1984 Corvette: Recall: Rear Axle Differential Cross Shaft Retention

Subject: REAR AXLE DIFFERENTIAL CROSS SHAFT RETENTION

Model and Year: 1984 CHEVROLET CORVETTE MODELS

Bulletin Number: 84-C-25 - (09/20/1985)

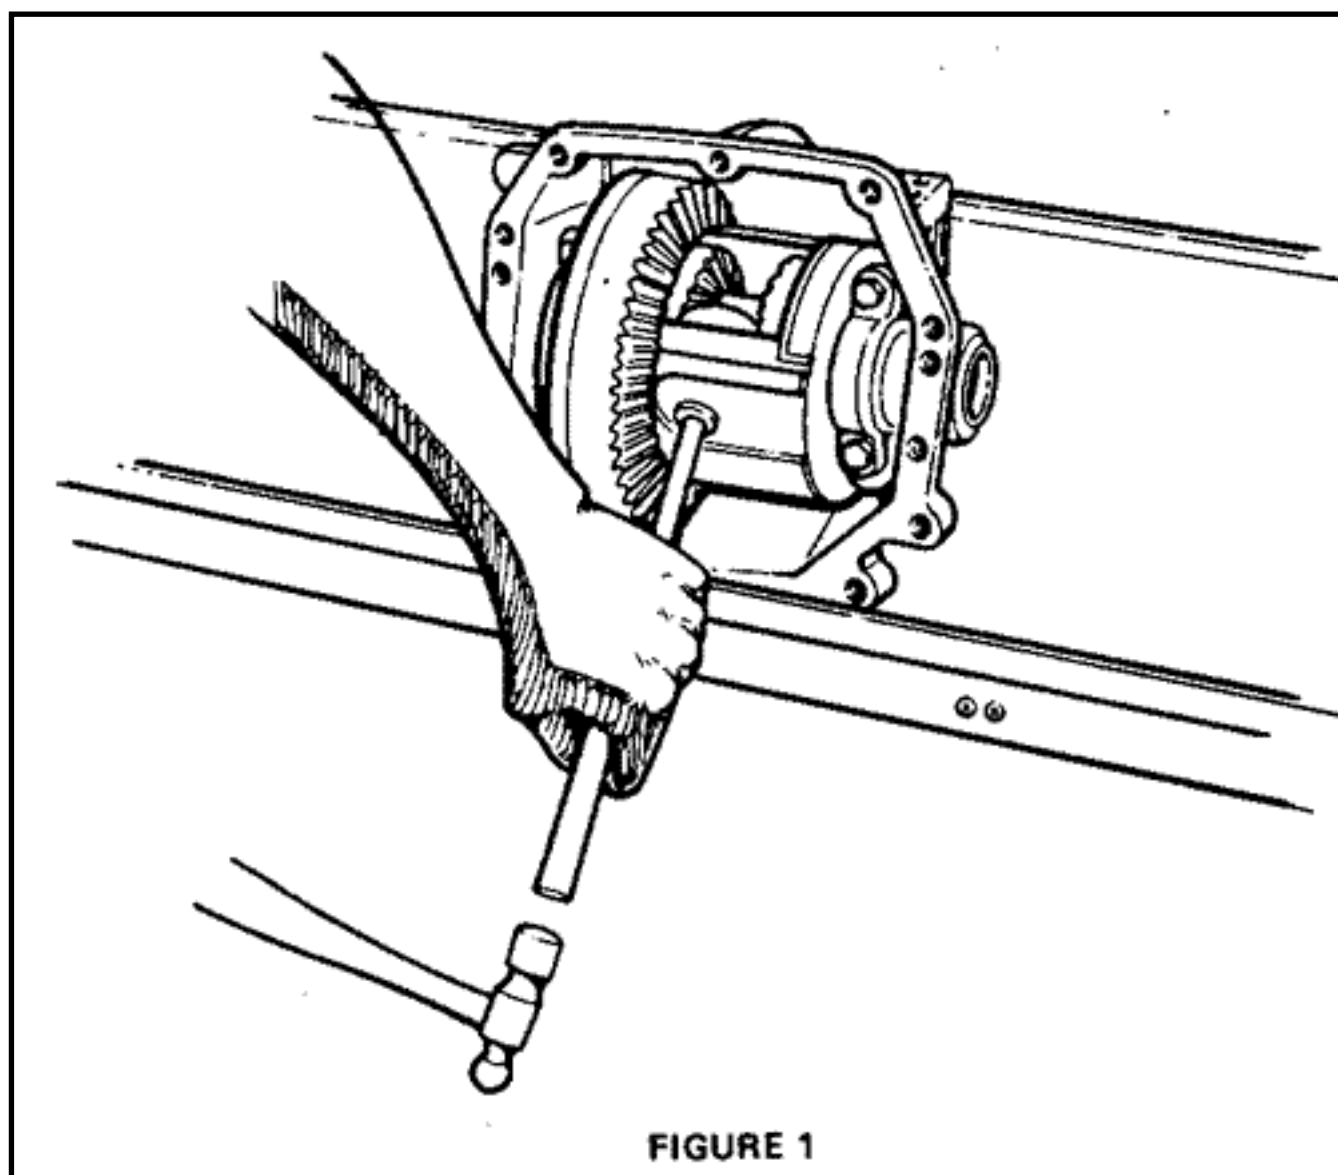
5. Rotate case assembly to position illustrated in Figure 1. With appropriate size drift and small mallet, lightly tap on cross shaft to determine if movement of shaft can be achieved.

FIGURE 2

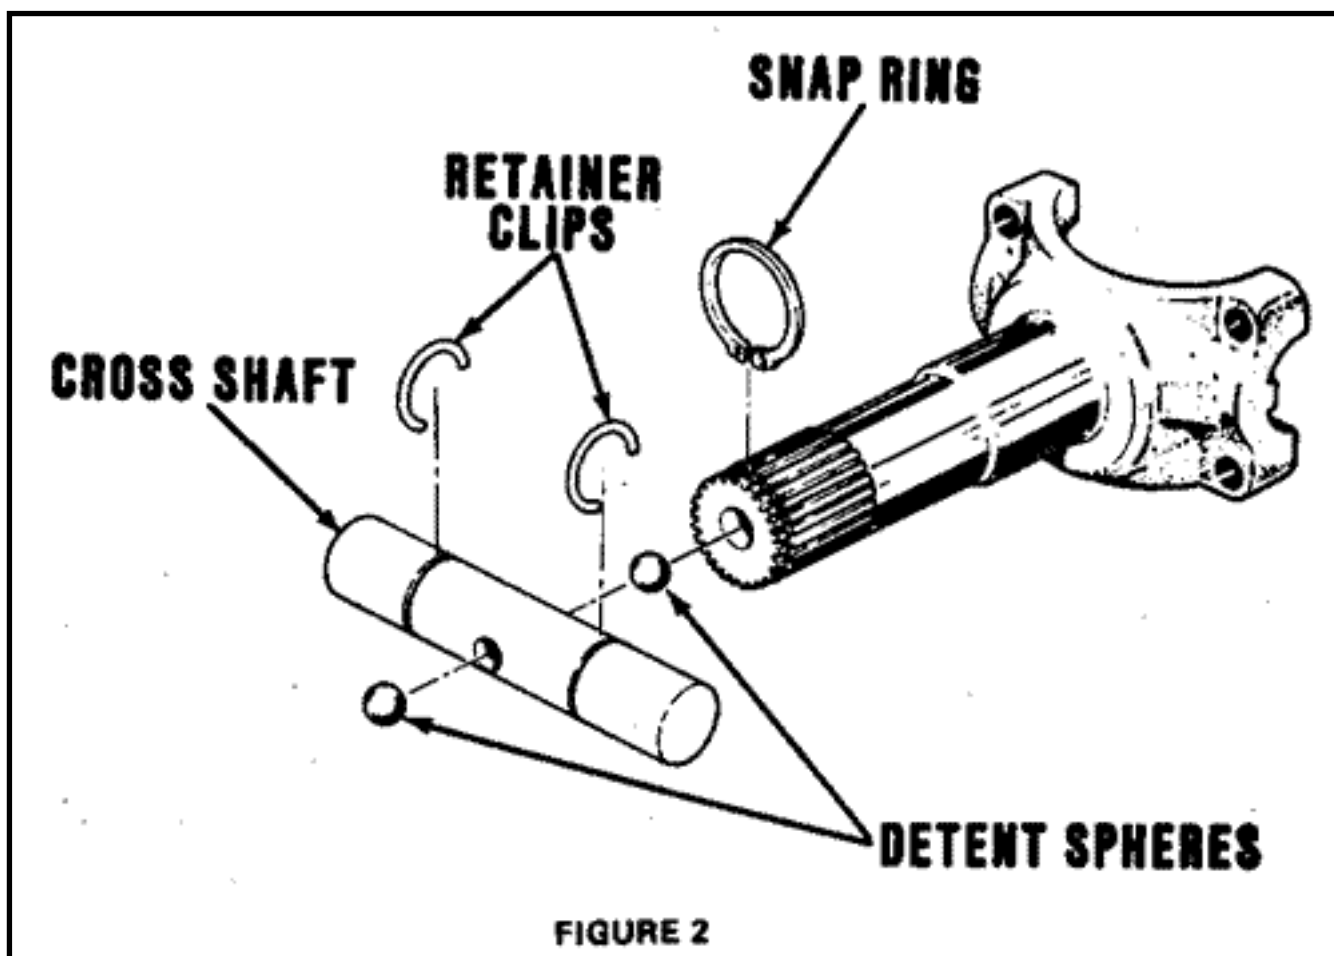
Tap cross shaft inboard approximately 1 1/4 inches and rotate case 180 DEG. Utilizing vise grips and a back and forth motion, remove shaft. Install new cross shaft insuring detents in the shaft are positioned properly to accept spheres (balls) to be installed, between shaft and output yokes as illustrated in Figure 2.

Remove case assembly from carrier following appropriate procedure in 1985 Corvette Shop Manual. Press existing cross shaft out of case and install new cross shaft insuring detents in the shaft are positioned properly to accept spheres (balls) to be installed between shaft and output yokes as illustrated in

Figure 2. Reinstall case assembly following appropriate 1985 Shop Manual procedure.
